RIVERPLACE PARCEL 3
DESIGN ADVICE REQUEST II PACKAGE

03.28.2016

DAR | FEBRUARY 18, 2016

WEST ELEVATION

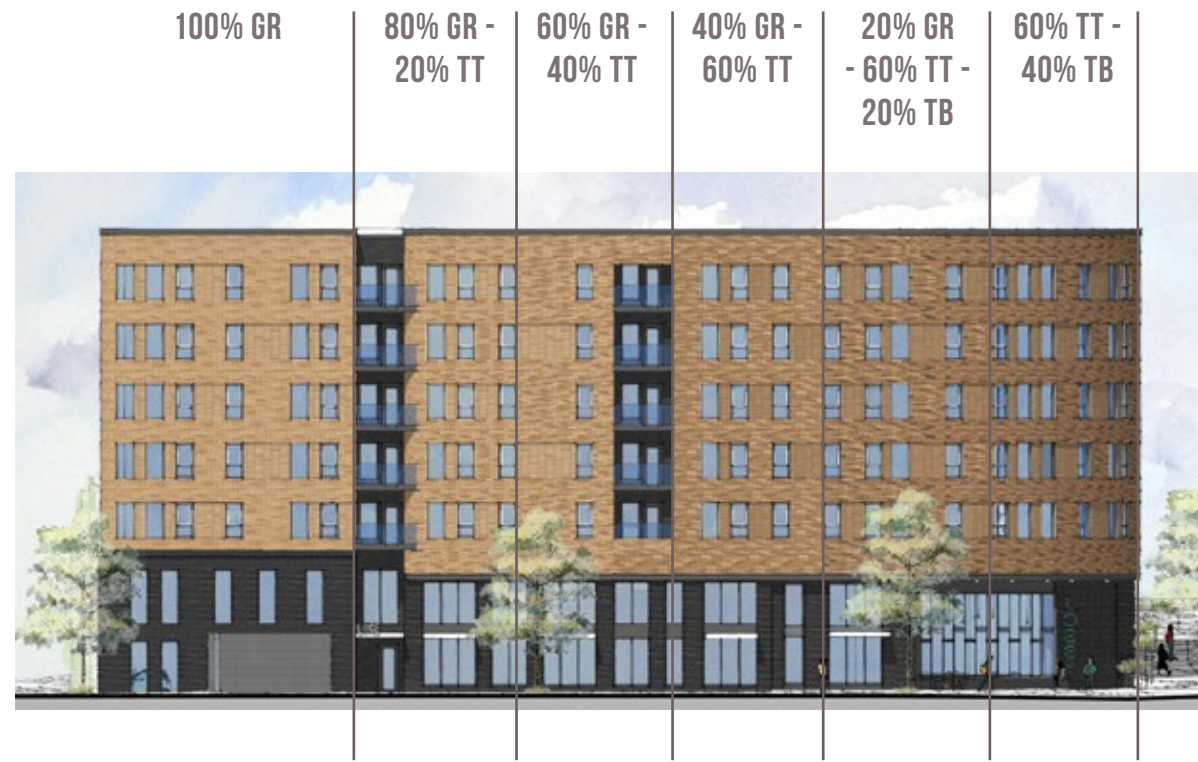
- The East building should be calmed down.
- The northeast corner of the East Building could be a very successful, nice urban experience, but one Commissioner recommended working on the geometries of this corner, which seemed a little awkward.
- Canopies will be important to include along the ground floors.
- Regarding balconies, there was agreement that the East Building needs more.
- Commissioners were very skeptical of the proposed brick gradations on the East Building and recommended pursuing a simpler brick concept.

- Number of window types have been simplified, accentuating the curve of the facade.
- The northeast corner has been refined to create a strong reading of entry for the apartments.
- Canopies have been added at all major ground floor entries and other locations so that pedestrians will not have long distances to traverse without weather protection.
- Applied decks have been removed and replaced with recessed decks.
- The number of decks have been increased by 4 decks.
- The brick gradient has been further developed and simplified.
